This information is based on the September 5, 2013, exception letter requirements for:

Required Isolation of Water in Different Stages of Treatment and Equipment Not Used in the treatment of RR WWTP Effluent.

All Engineering plans referred to in blue are from the October, 2013 CWF 13-550-16 plans.

Photograph of 2008 Raw Water Vault with RR WWTP Connection

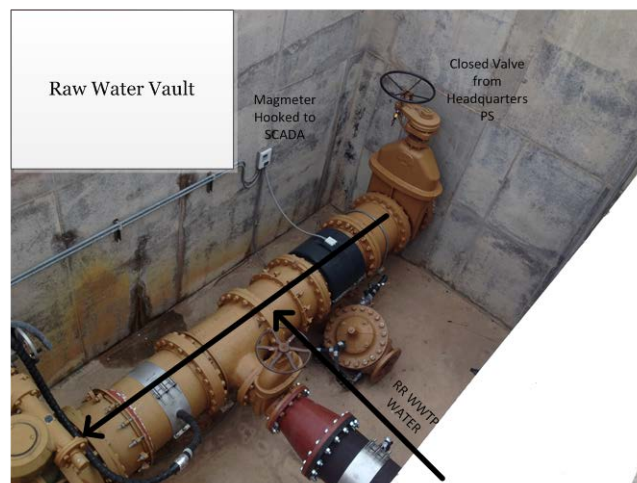
- a. The 2008 SWTP flow control vault's valve located on the Lake Kemp/Headquarters Road Reservoir pipeline must remain closed at all times during the verification testing (and during the proposed six-month temporary discharge of potable water to the distribution system). The City must take the following actions:
 - i. The valve and flow meter after the valve and before the tee must be inspected at least once each eight-hour shift;

*The City will be able to accomplish this by reading the meter and information on the SCADA System and by physically observing the chain around the valve as noted in Sheet 8 Detail 10.

Photograph of additional piping added from the 2010 clear well to use for backwashing purposes and also 2010 filtered water to the recovery well and the 90 degree piping removed and blind flanged as shown in Sheet 5 detail 4.

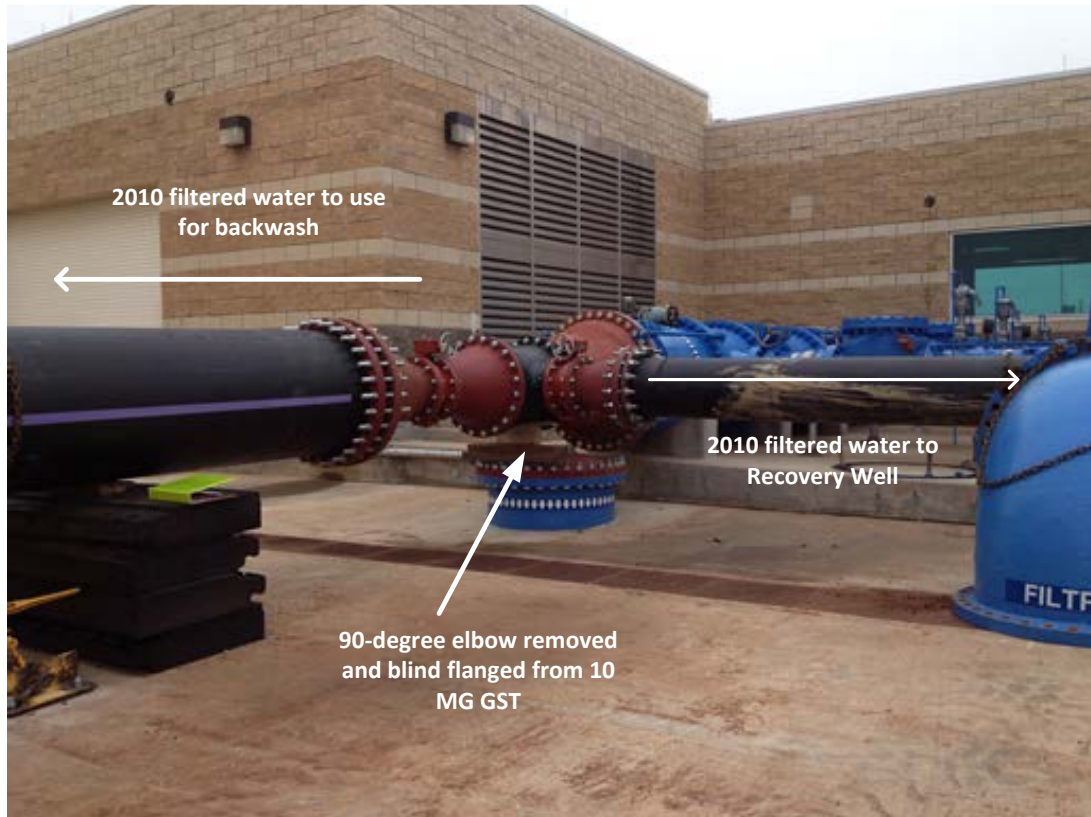
- e. A 42-inch, 90-degree elbow must be removed (as proposed by the City in your email dated July 29, 2013) from the 2010 SWTP transfer pumps' discharge and the discharge piping connected to the temporary 12-inch, above-ground pipe discharging into the manhole that drains to the 2010 SWTP recovery well located on waste Lagoon No. 2. A blind flange or cap must be installed on the 42-inch pipe to the 3.0-MG, 5.0-MG and 10.0-MG GSTs to prevent the entrance of contaminants during the DPR WTP's verification testing and TCEQ-approved temporary operation.

Photograph of the connection for new 2010 filteres water line for backwash purposies connecting into the existing 1987, 1961 and 2010 backwash line. The Water line from the existing backwash pumps is blind flanged as detailed in Sheet 5, Detail 4.

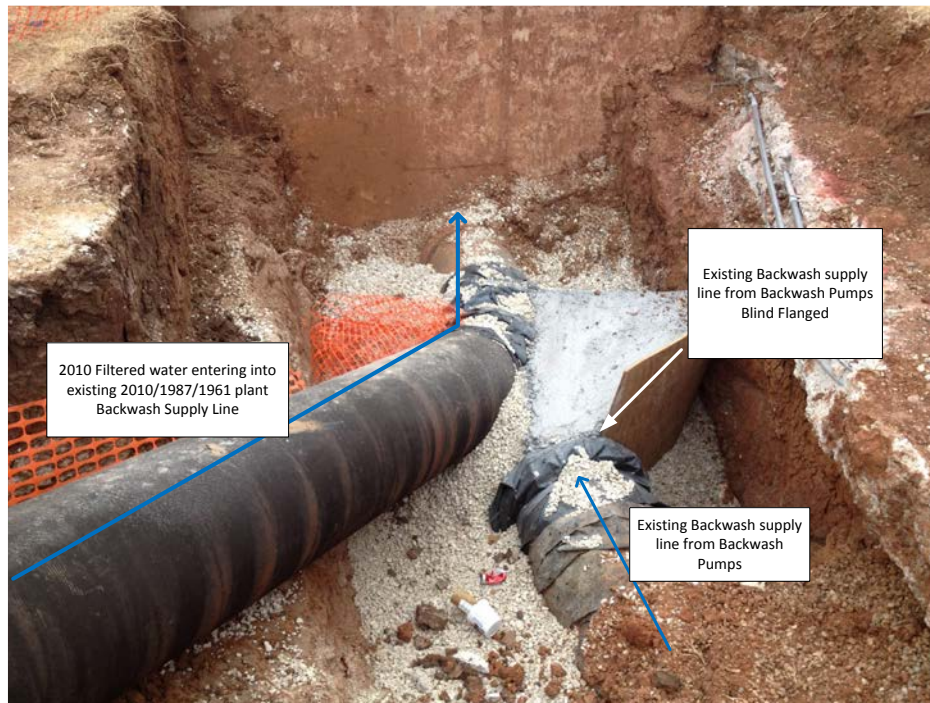
- g. The backwash supply pipe for the 2010 SWTP gravity media filters must be disconnected from the backwash pumps' pipe coming from the Cypress High Service Pump Station during the verification testing. The pipe from the pump station will need to be temporarily plugged or capped at the point of disconnection to prevent the entrance of contaminants. During the verification testing, the City will need to use one of the following methods to supply backwash water for the 2010 SWTP gravity media filters by temporarily connecting the backwash supply pipe at the 2010 SWTP gravity media filters either:

The City decided to utilize 2010 filtered water backwashing purposes. They are going to close off the discharge line to the recovery well and utilize the transfer pumps and the new 24" HDPE back wash line as detailed in Sheet 5, detail 4, detail 5 and Sheet 6 detail 6.
